Change Order - Construction Manager-Adviser Edition

PROJECT (Name and Address)
STANTON ELEMENTARY SCHOOL
WEST COLLEGE AVENUE
STANTON, KY 40380

CHANGE ORDER NUMBER: 21-01
INITIATION DATE: 4/16/2024

PR #01 Wick Drains

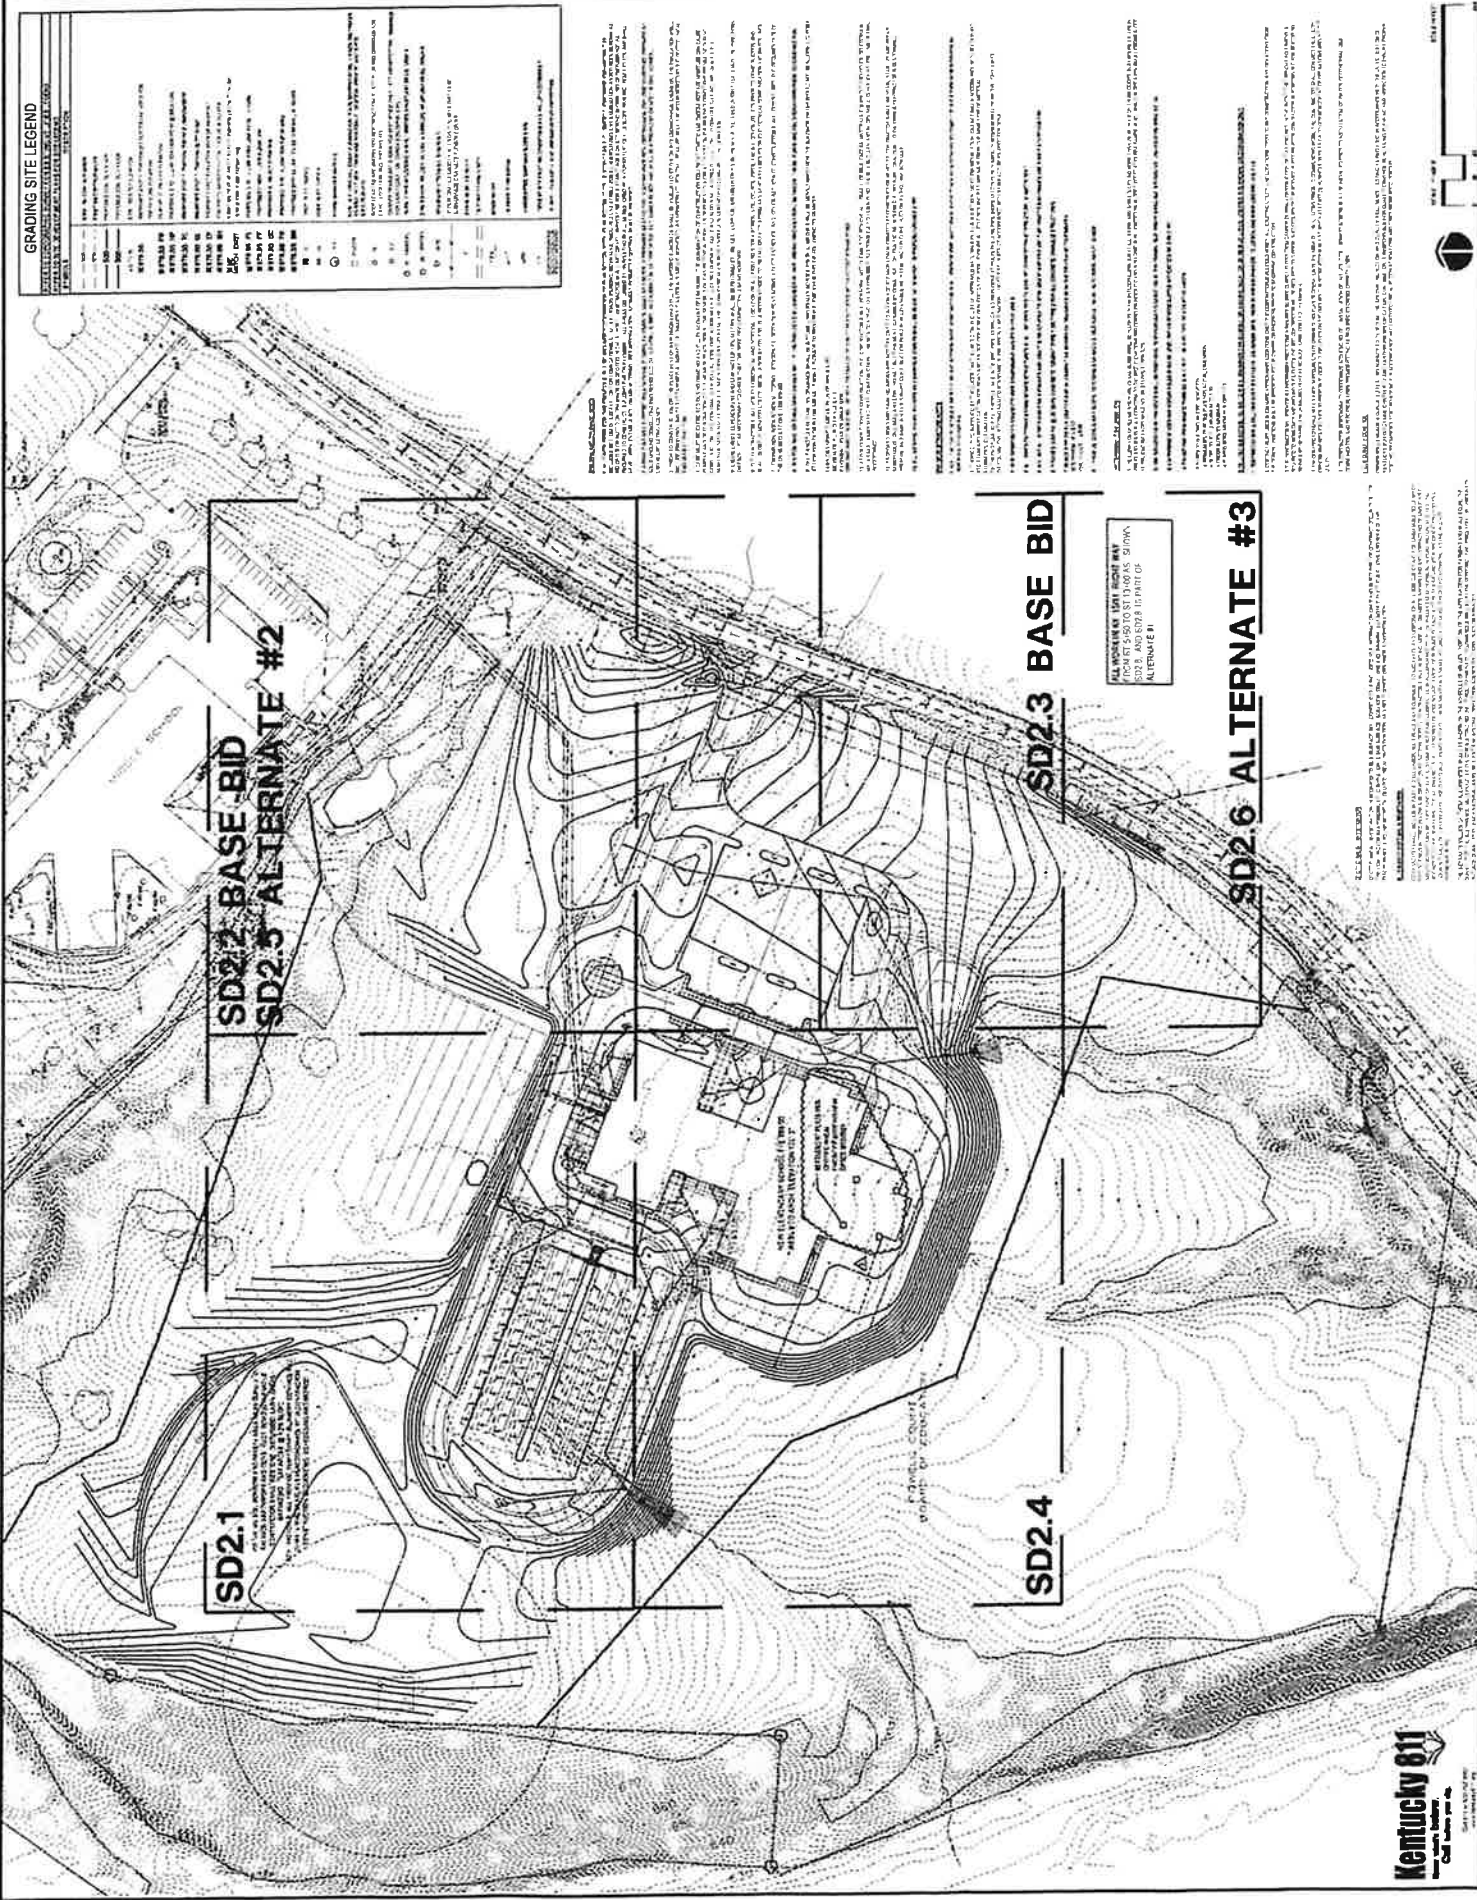
Settlement plate layout.

Figure 1 – Approximate Locations

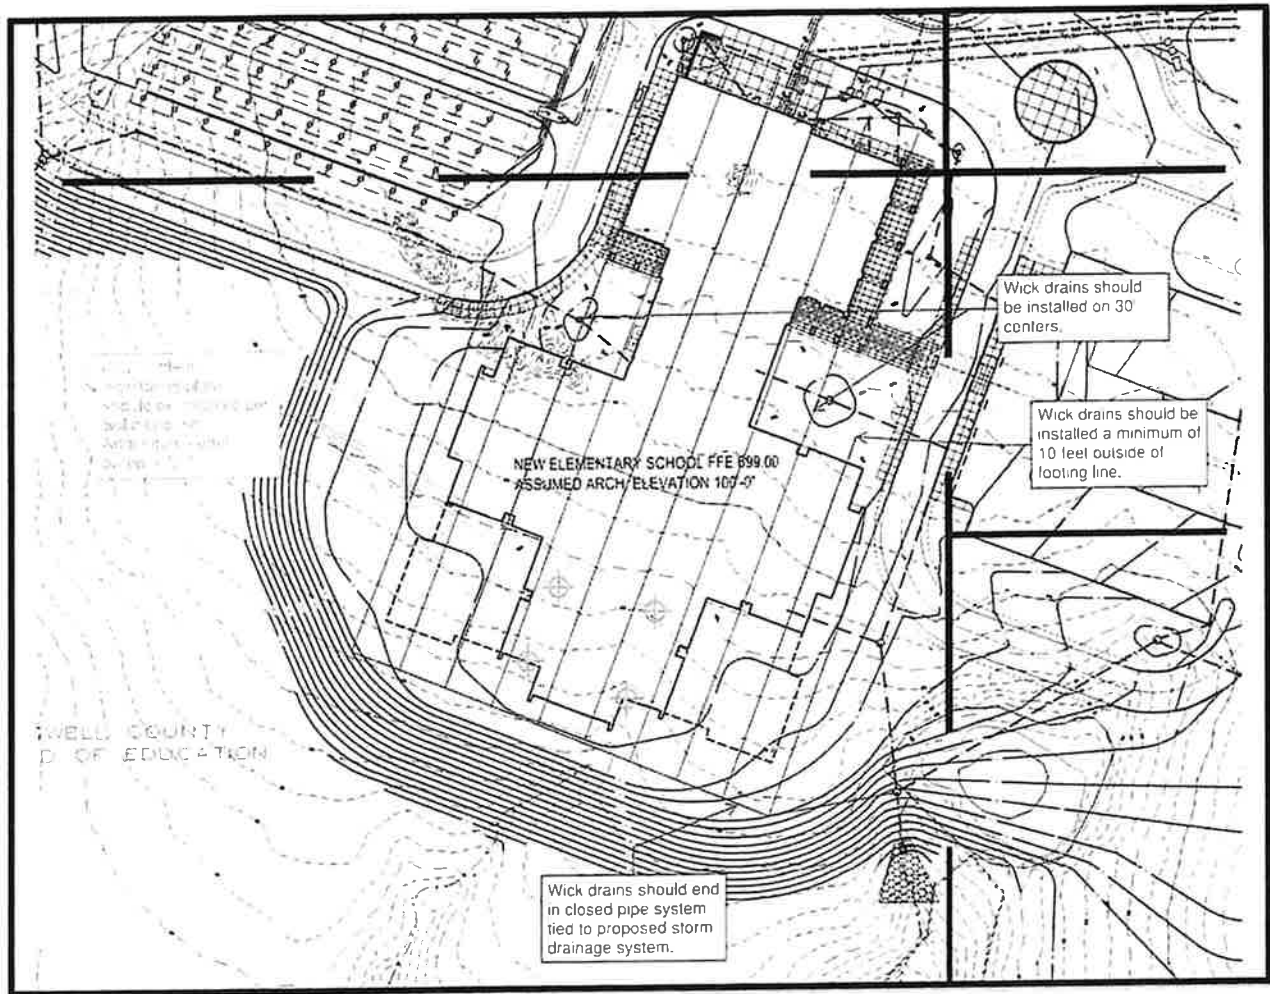
Due to the high in-situ moisture content of the subgrade soils and the known 10+ feet of fill, we are recommending a modified wick drain implementation. The wick drains will assist in dewatering the site and aid in consolidation of the proposed fill soils.

Wick drains should consist of a 4" perforated pipe that is wrapped in filter fabric. Wick drains should be embedded with a minimum of 6" of open grade stone (#57 to #8). Wick drains should be installed a minimum of 3 feet into existing grade or the width of the nearest footing, whichever is greater. Wick drains should be installed with 30 foot spacings and should extend a minimum of 10 feet past the outside edge of footings. The wick drains should end into a closed pipe that is tied into the proposed storm drainage system. Figure 1 shows the approximate locations of wick drains, drain lines, and settlement monitoring plates.
